ADDENDUM NO. 11
15 June 2009

Project: **THE NEW TEXAS CITY HIGH SCHOOL**
Texas City Independent School District

Bay Project No.: **0748**

ADDENDUM 11-01

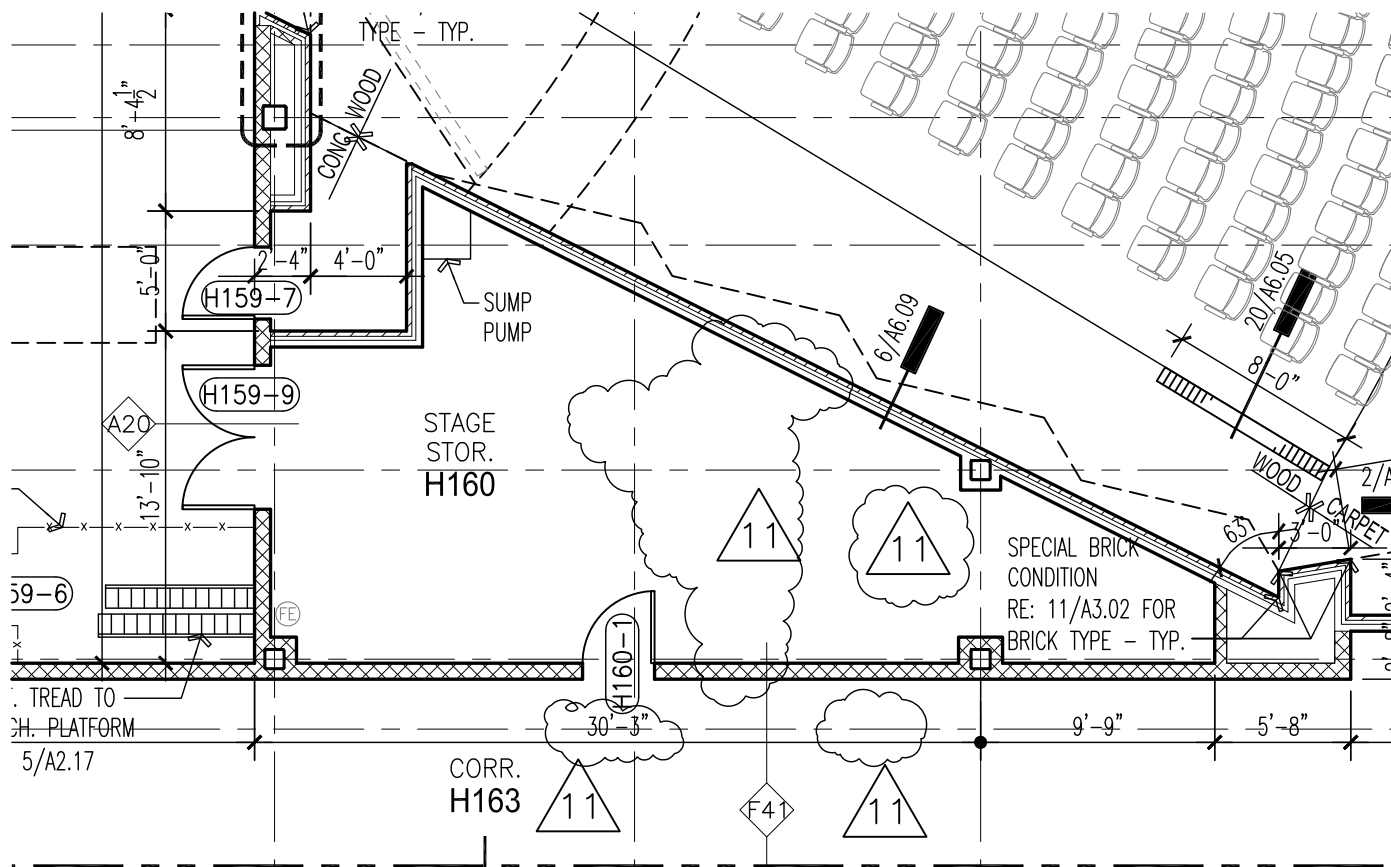
22. Sheet A2.15: Doors H101-2, H121-1, H136-1, and H137-1: change remarks "WAD" to read "STC 39". Delete references to "WAD".
23. Sheet A2.16: Delete wall and door between Stage Storage Room H160 and H161. See attached **ADD-11-01**.
